UNITED STATES PATENT AND TRADEMARK OFFICE

09/678,025

Office Action Summary

DETAILED ACTION

FIG. 21

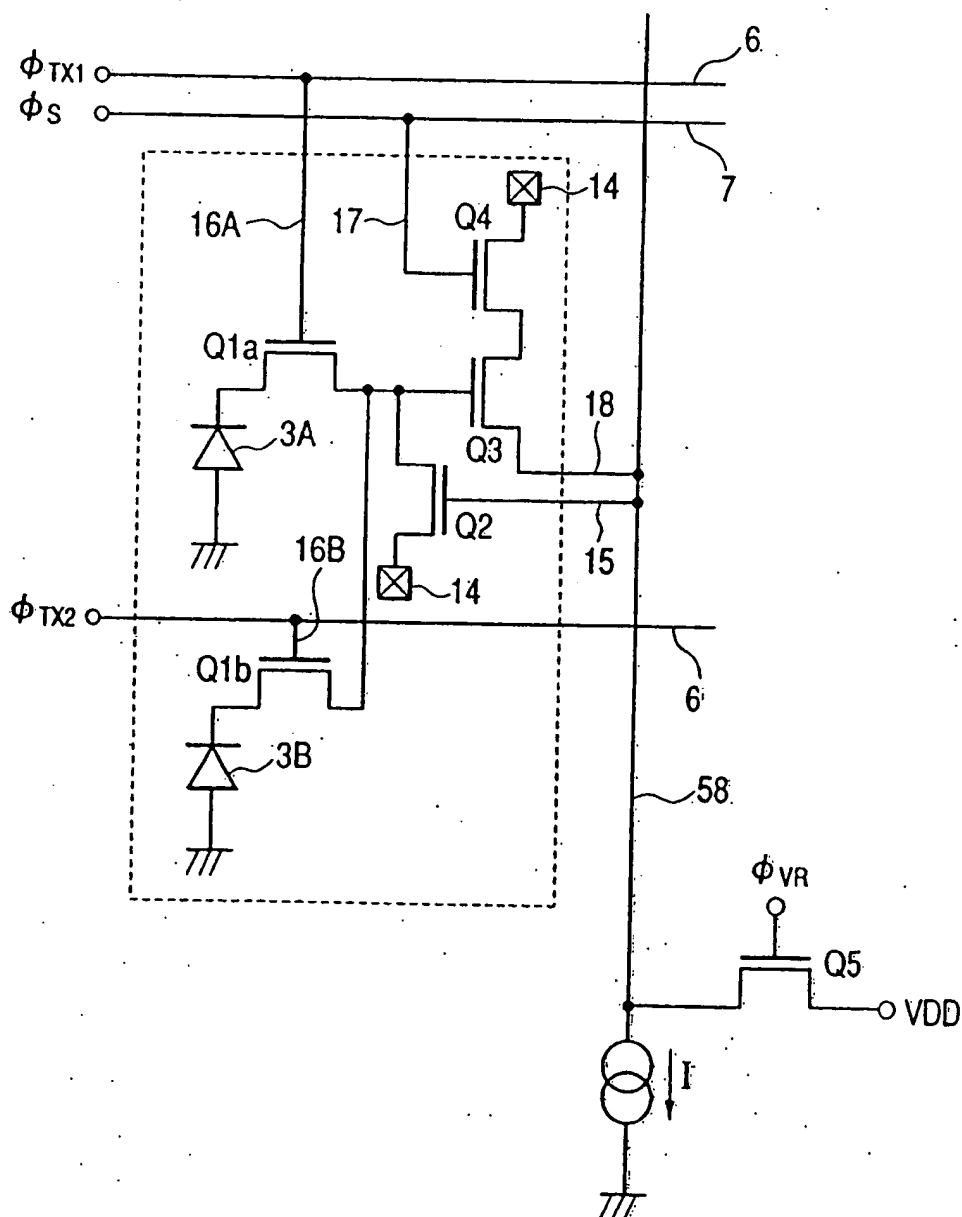
Approved
CK
10/12/05

FIG. 23

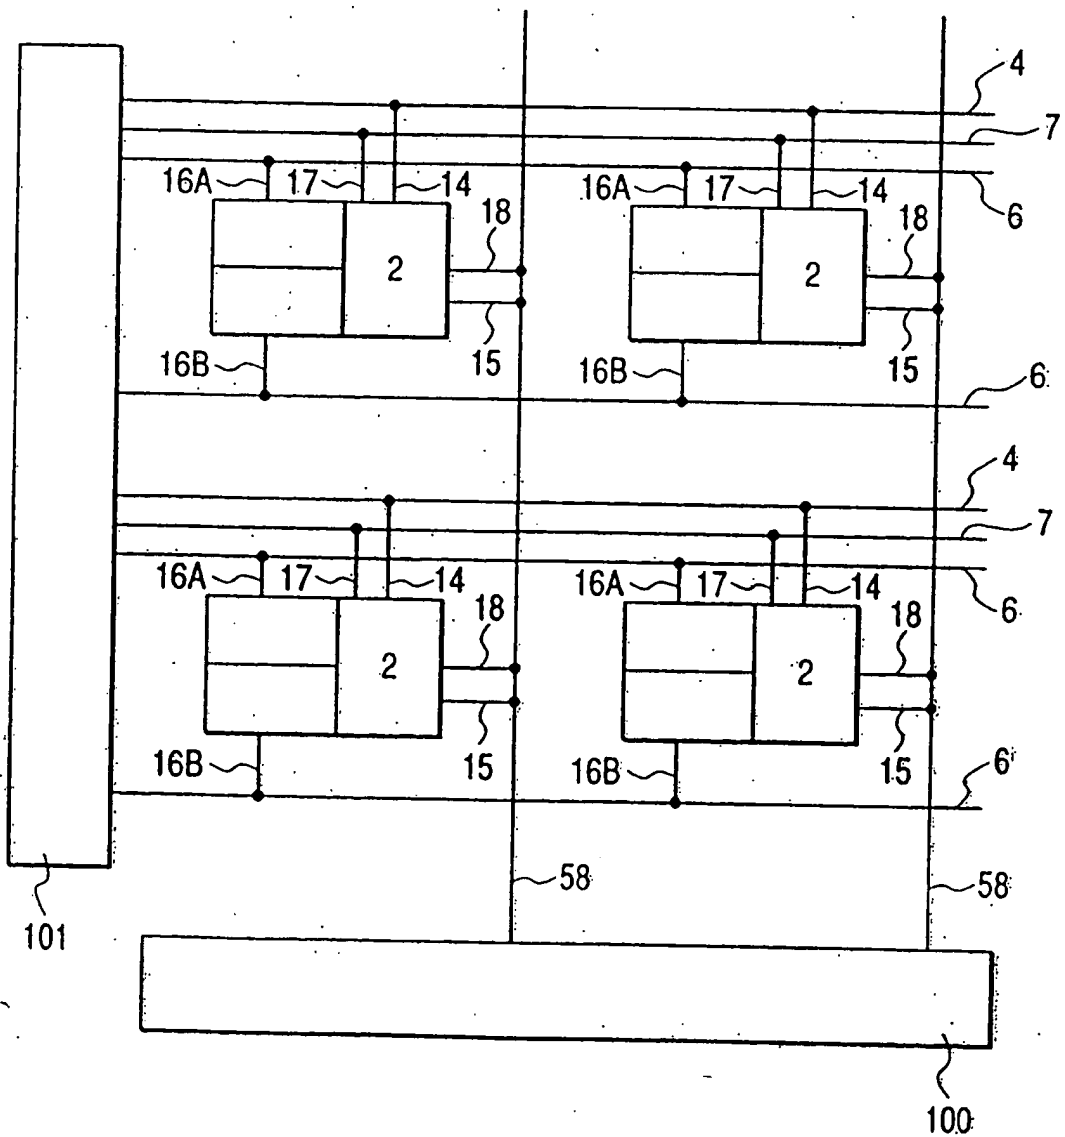
Approved
10/12/05

FIG. 25

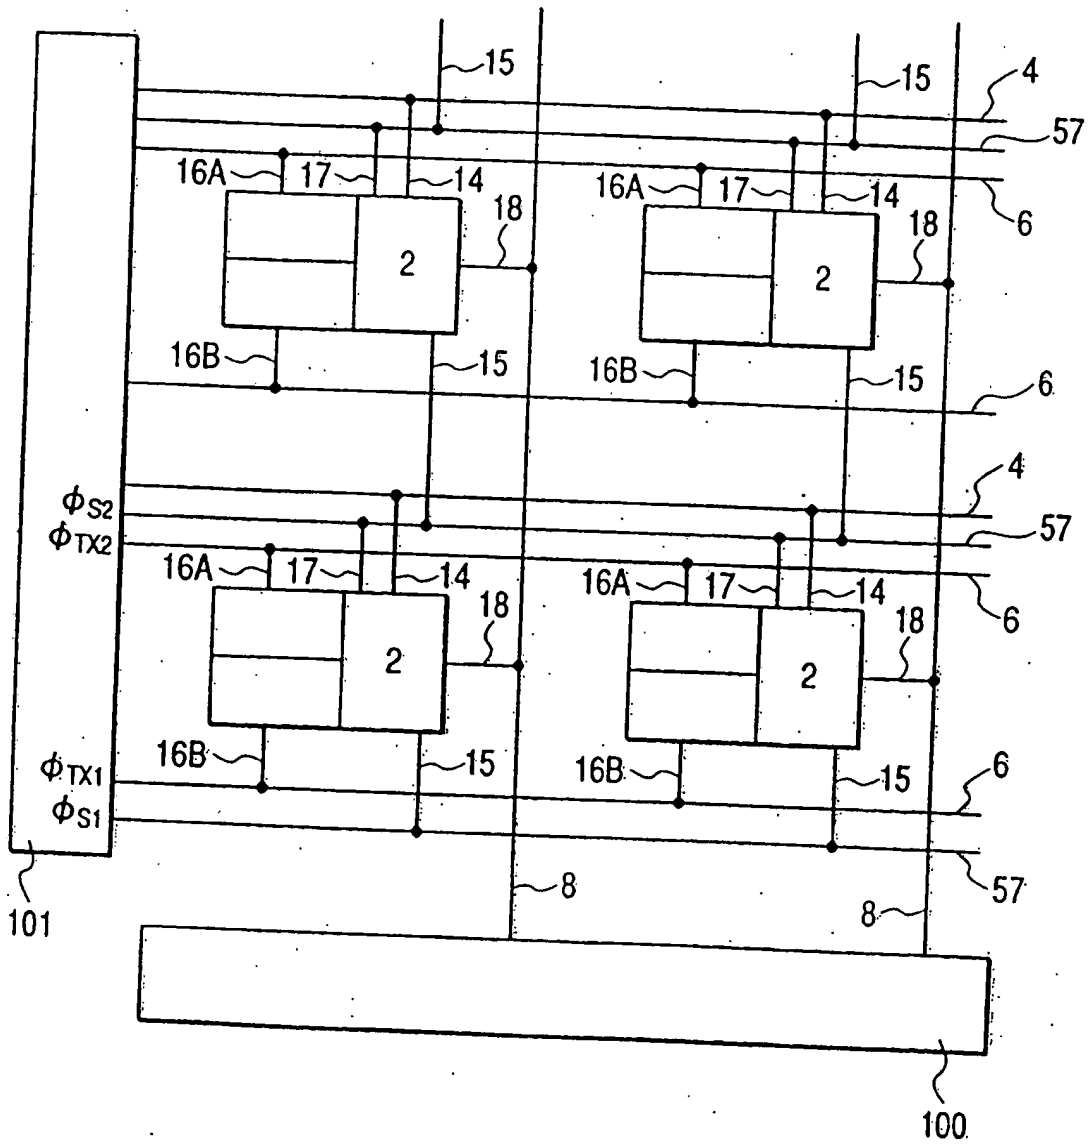
Approved
10/12/05
